**Re: Second Submission Review: QuikTrip 4263 – Site Plan & Conditional Use**  
**Application Number:** DA-1483-03  
**Case Numbers:** 2000-6044-07; 2000-6044-08

# QUIKTRIP 4263

## SITE PLAN AND CONDITIONAL USE

QUIKTRIP 4263  
PARKER RD. & HAVANA  
SITE PLAN  
DETAILED SITE PLAN

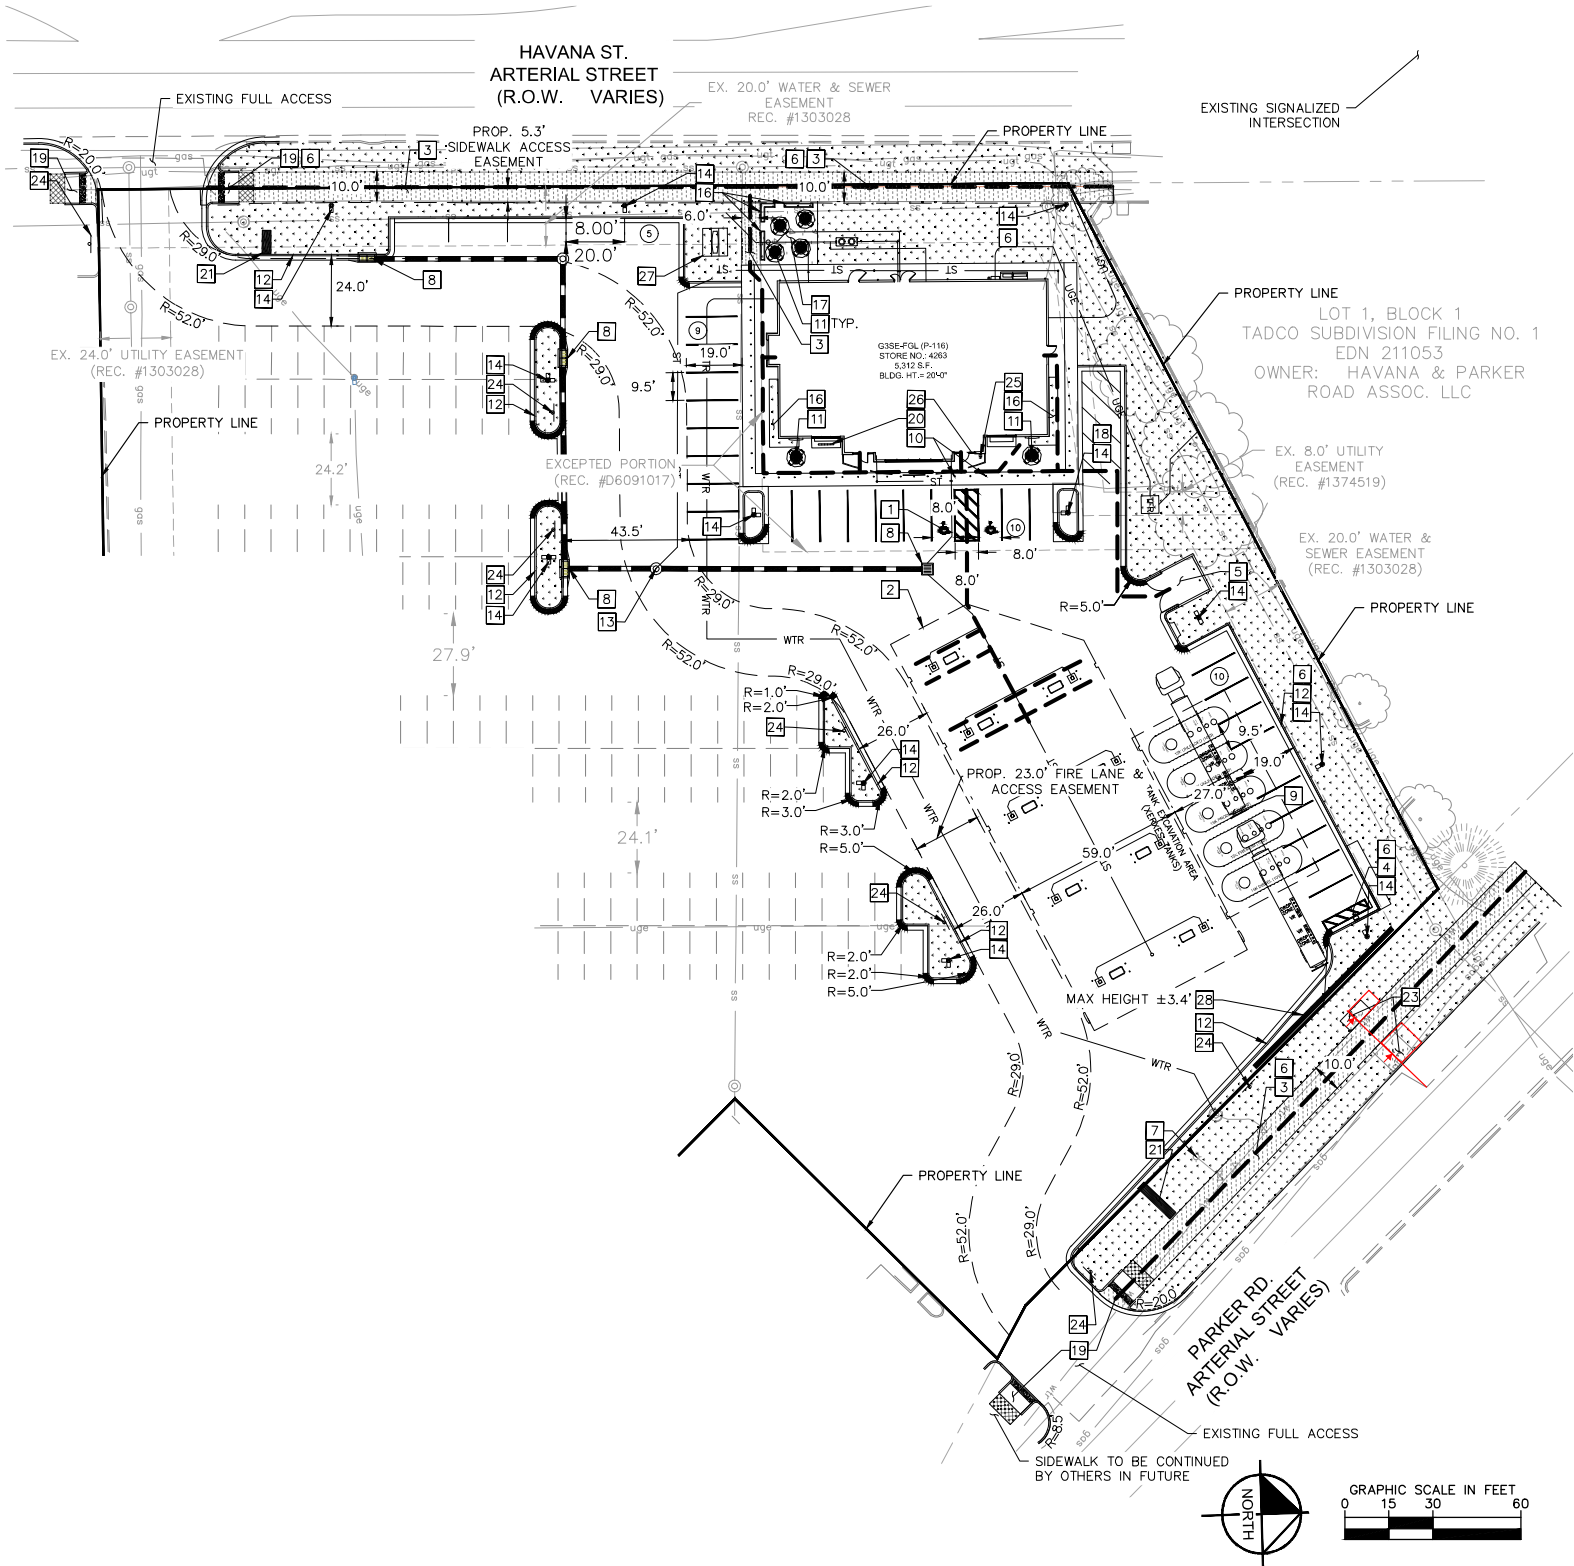
- 1B. There's a typo on-site plan note 27 for the "Single Tenant Monument Sign".

- 6B. Clarify that both of the monument signs shown on the site plan notes are multi-tenant signs. If any single-tenant monument signs are proposed, include them as well.

- 9A. Curb return radii at Arterial and driveway intersections at both Parker and Havana entrances should be a min of 25'.

- 10A. Consider adjusting the fire lane so it does not encroach with the parking stalls on the southern side of the storefront.

- 11A. See note to adjust the fire lane so the parking stall does not encroach.
- 11B. See comment for emergency fuel shutoff switch location.

- 13D. Fire lane easement needs to be dedicated by separate document.
- 13E. The other easement dedications (Fire Lane and Access easement; Water Easement) by separate documents should be completed prior to any building permits. (submit documents to [dedicationproperty@auroragov.org](mailto:dedicationproperty@auroragov.org)) The intake team will process them and move them into the system.
